UNITED STATES ENVIRONMENTAL PROTECTION AGENCY WASHINGTON, D.C. 20460

MEMORANDUM

Ciba-Geigy proposed waiver of 50-ft. set-back for

atrazine mixing/loading/storage sites (DP Barcodes

Concrete Estimating

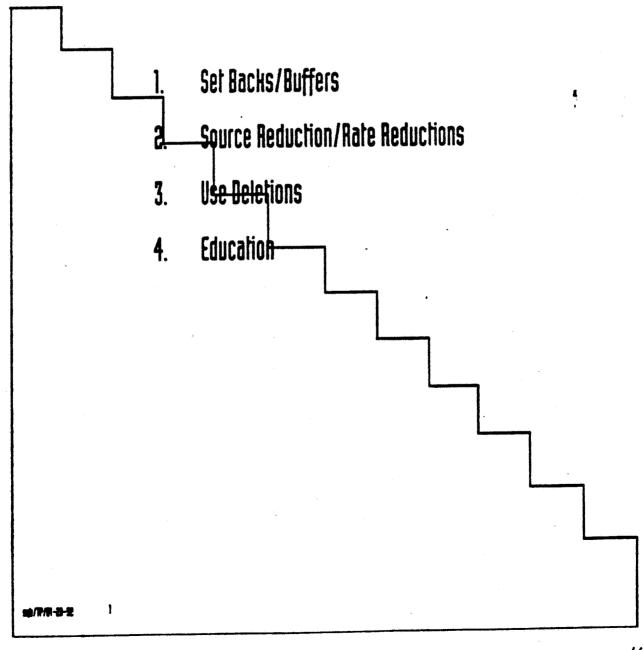
The chart below can be used in estimating amounts of concrete. For the 4" X 20" X 40' concrete pad, read down the left column of the table to the depth of the concrete in inches, which is 4". Reading across you will find that one cubic yard at that depth will fill 81 sq. ft. The area of the pad is 800 sq. ft. (length X width). Next divide the total square feet by the number of squar feet covered by one cubic yard of coment:
